ATTACHMENT C

- City's Letter to SAPCB Members, Permit Requirement for Stack Merger Project, Mirant PRGS, September 12, 2007
- City's Letter to David Paylor and SAPCB Members, New Source Review Permit for Construction of Stack Merger and Comprehensive SOP for Mirant PRGS, October 5, 2007
- City's Letter to David Paylor and SAPCB Members, Comprehensive SOP (2 Stack version) for Mirant PRGS, October 9, 2007

**Re: Permit Requirement for Stack Merger Project
Mirant Potomac River Generating Station, Alexandria, Virginia**

**Re: New Source Review (NSR) Permit for Construction of Stack Merger and
Comprehensive State Operating Permit for Mirant Potomac River
Generating Station, Alexandria, Virginia**

Daily Average PM2.5 Levels at Marina Towers and at Fairfax County's Annandale Monitor* - April 11 - June 12 2007

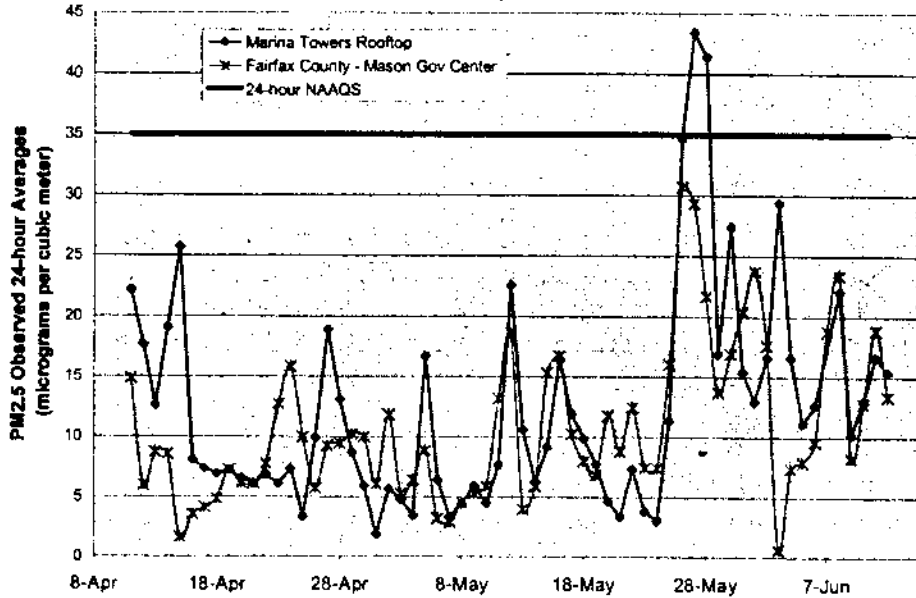
Alexandria has also collected several months of ambient PM_{2.5} data at the roof of Marina Towers during 2007. The following chart is a summary of the monitored concentrations, along with simultaneous data from a regional monitor. The table below shows more detailed monitoring data during three days in May 2007 when concentrations at Marina Towers approached or exceeded NAAQS. The data shows that concentrations at Marina Towers often exceed the regional values and in some cases exceed the NAAQS level. These data further enforce the need to evaluate PM_{2.5} emissions from the PRGS.
